SERVICE BULLETIN

SUBJECT: FARGO AUXILIARY FUEL TANKS P/N - A1066-1082

FARGO SERVICE NOTICE NUMBER 2 ; Revision No.1
30 December 1985

SUBJECT: Leaks in Fargo Auxiliary Fuel Tanks

FIGURE 1

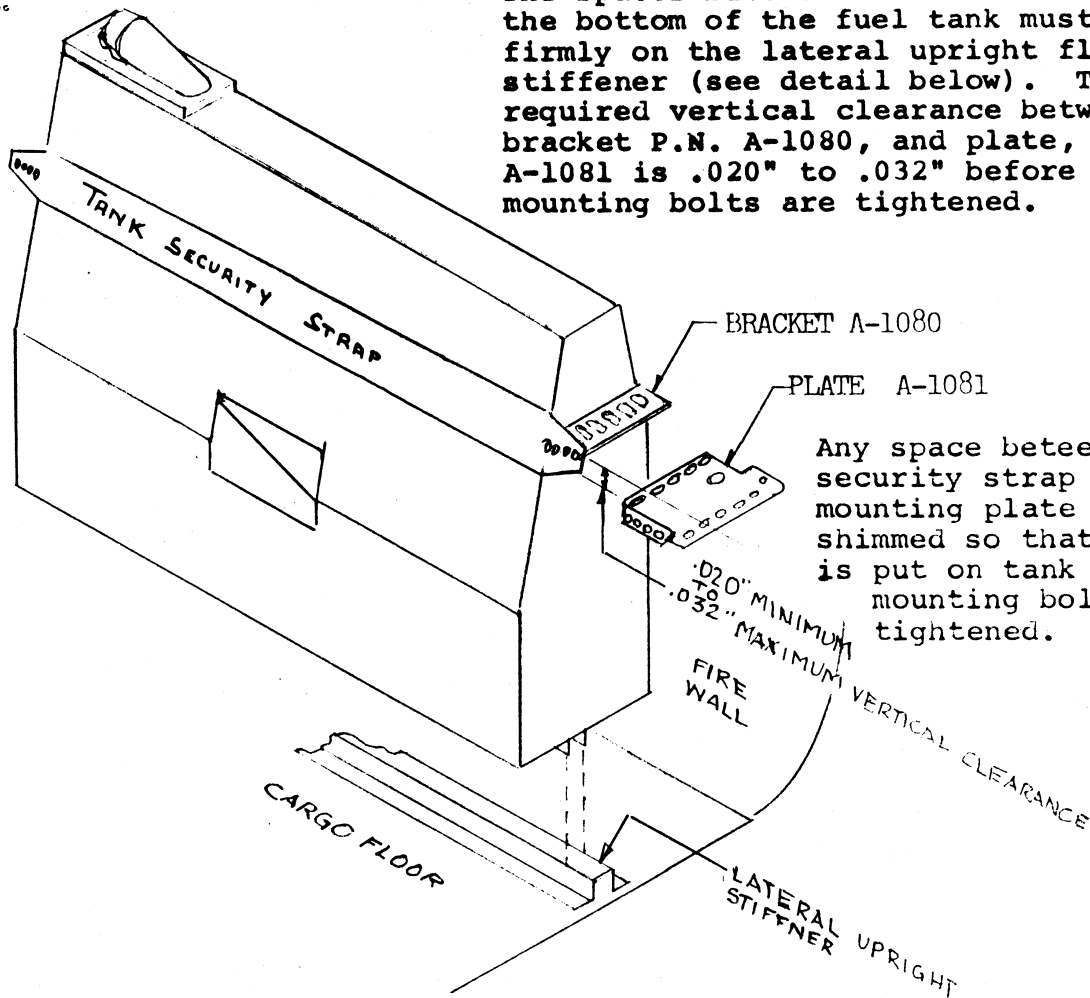
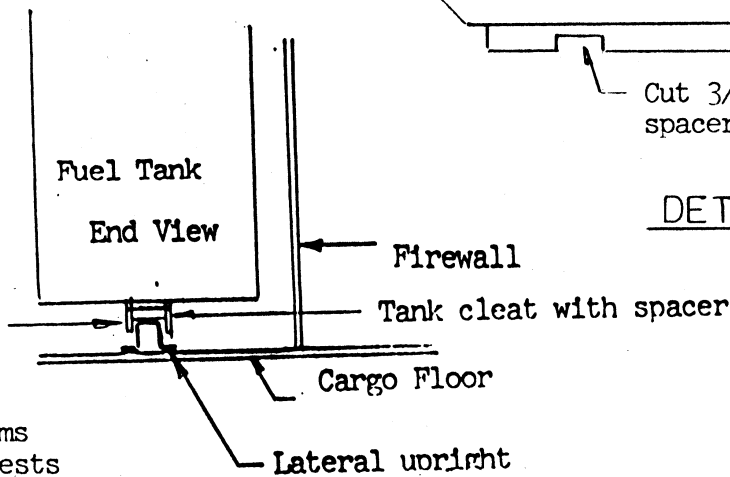
2. If there is any space between the bottom of a spacer block and the floor stiffener, repair steps I through M must be performed. See Figure 1, Detail 2, Page 6 of 6.

The spacer blocks in the "U" channel on the bottom of the fuel tank must rest firmly on the lateral upright floor stiffener (see detail below). The required vertical clearance between bracket P.N. A-1080, and plate, P.N. A-1081 is .020" to .032" before the mounting bolts are tightened.

Cut 3/4" wide slots at each spacer block location.

If airspace exists when tank is placed in position, use additional spacer shims to insure that tank rests firmly on the upright floor stiffener.

- I. Machine two (2) separate spacers from aluminum that will:
 - (1) Fill the space between the bottom of the spacer blocks and the floor stiffener, and,

- (2) Provide a .020" to .032" vertical clearance between each tank mounting bracket (P/N A-1080, item 2) and its mating mounting plate (P/N A-1081, items 19 and 20). See Details on Page 6 of this notice.
